**Addendum No. 1**  
**City of Coquitlam**  
**Tender No. 51163**  
**Princeton Ave Utility Construction & Road Grading**  
 (Consists of 17 Pages)

Issue Date: March 9, 2026

Tenderers shall note the following changes:

**STORM SEWER**

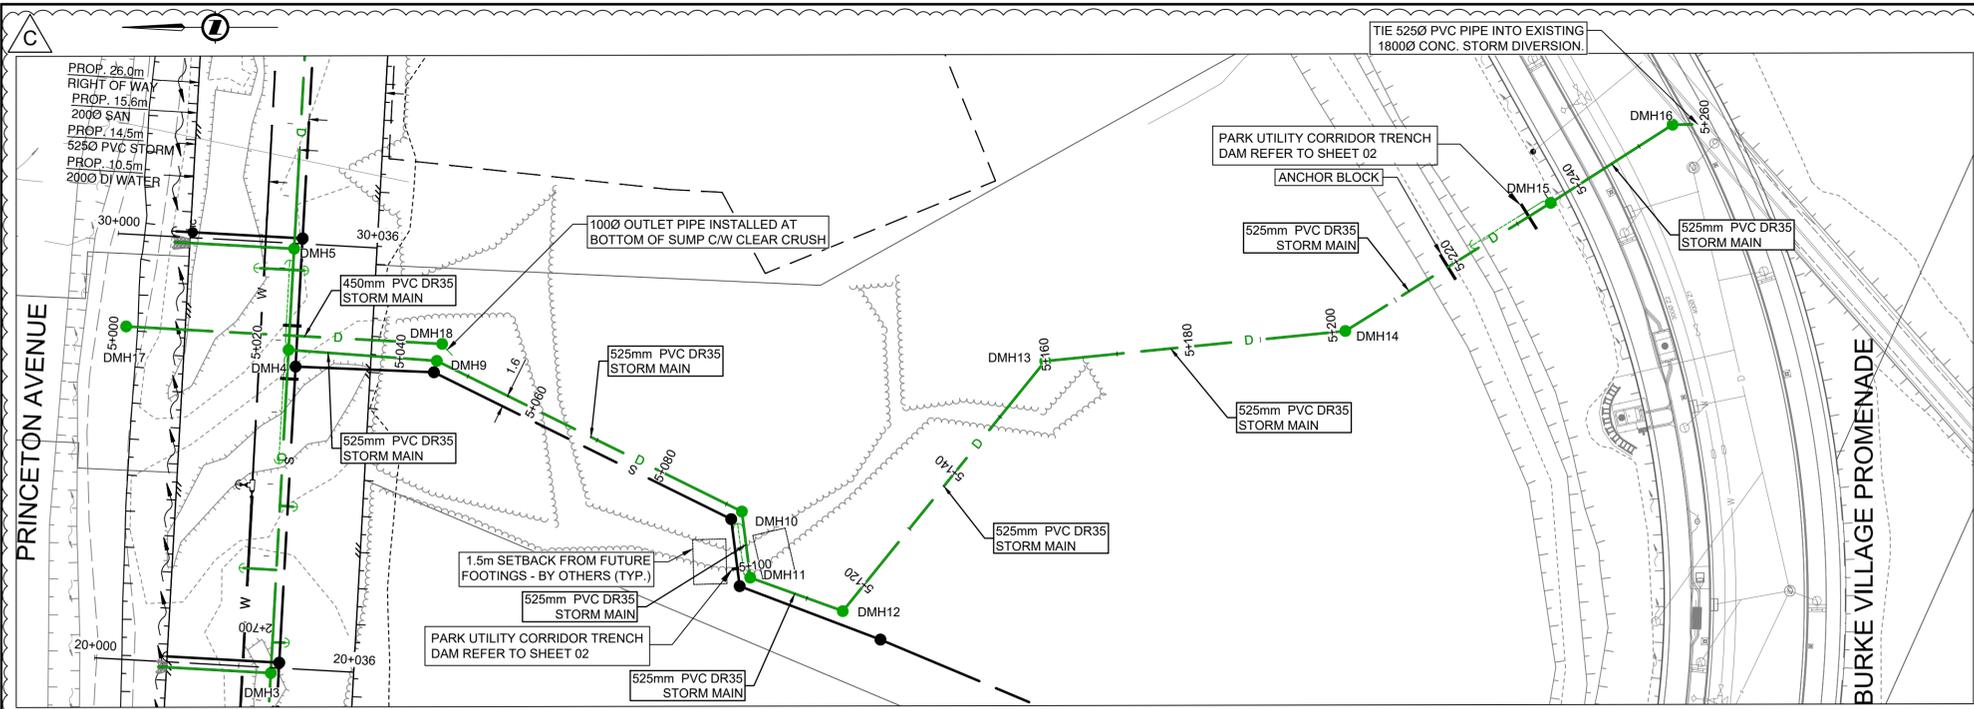
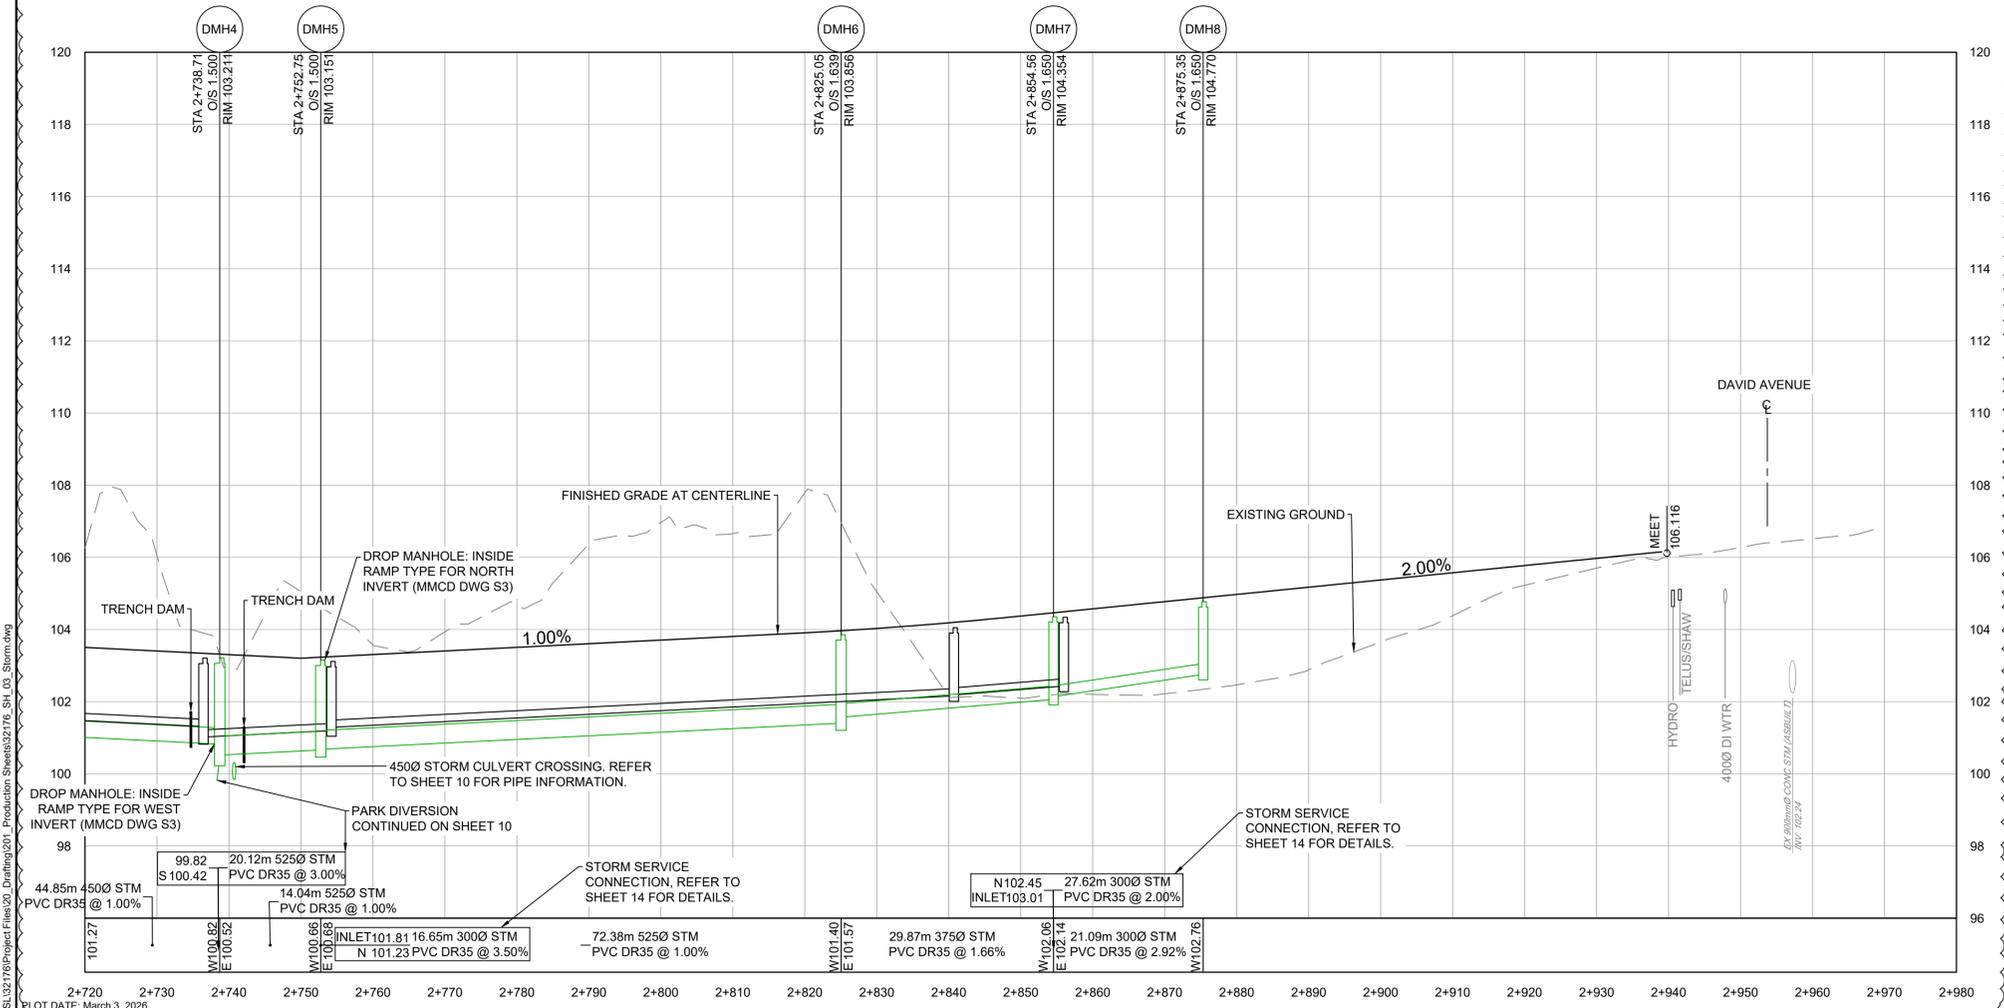
Q2) For 1200mm MH D4 and D5, the details indicate an inside drop; however, the incoming pipe diameters are 450mm and 525mm. Based on these sizes, the manholes may need to be upsized to accommodate an inside drop. Could you please review and confirm whether these manholes are to be upsized or if an outside drop should be used instead?

**A2) Drainage manholes DMH4 and DMH5 are Inside Ramp manholes as per MMCD S3. The callouts noting “Drop Manhole” will be removed in the Issued for Construction Drawings to avoid confusion.**
